Product Change Notice (PCN)

PCN Number: **PCN-0450972R-02**

Product(s) Affected: *SJ1-351XN Series. (SJ1-3513N, SJ1-3514N, SJ1-3515N)*

PREVIOUS CUI DEVICES DETAIL / IMAGE			NEW CUI DEVICES DETAIL / IMAGE

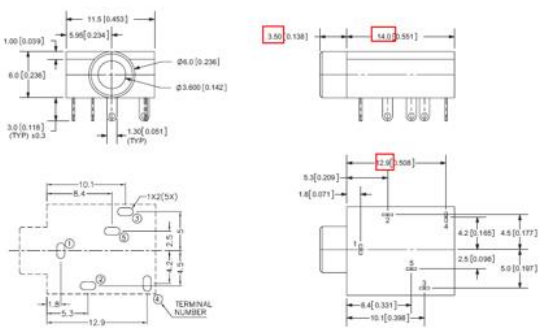
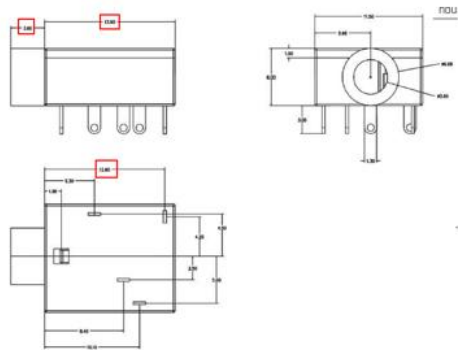
Description of Change: *Slight Dimensional difference. Terminal Material Change See image Below*

MATERIAL	PLATING	DESCRIPTION	MATERIAL	PLATING/COLOR
terminal 1	brass	silver	terminal 1	brass t=0.3	silver
terminal 2	brass	silver	terminal 2	phosphor bronze t=0.3	silver
terminal 3	brass	silver	terminal 3	brass t=0.3	silver
terminal 4	brass	silver	terminal 4	brass t=0.3	silver
terminal 5	brass	silver	terminal 5	phosphor bronze t=0.3	silver
bushing	brass	nickel	bushing	brass	nickel
spring	stainless steel		spring	steel	black
cover	PBT		cover	PBT (UL94V-0)	black
plastic	PBT		housing	PBT (UL94V-0)	black
